FOR AMY SCANLON – The architect I'm working with has been on vacation until today, the 26<sup>th</sup>. I will turn in my most recent set of plans with responses to your most recent corrections. However, the drawing will not show these updates on the original application I'm turning in today. I will have the corrected changes at most a week after I turn in my application to the landmarks and I will turn them into you ASAP.

Remarks (in bold) on most recent set of plans turned in and responses:

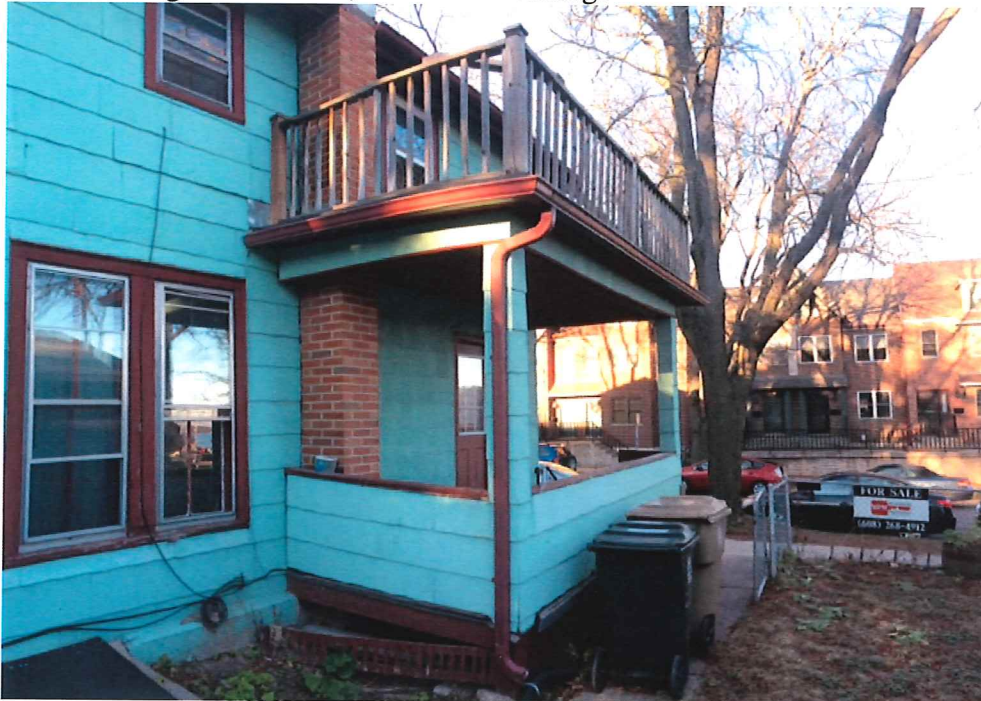
**Please provide photos/examples of porch columns, newels and railings. The drawings show some extra lines that should be simplified.**

Current design of columns, newels and railings –

What it will be –

Railings and Newels /only difference is they will be painted a cream color and a height of 42 inches

Design of columns /only difference is they will be a cream color. A more technical look is available on the Porch and Deck details in the set of drawings.
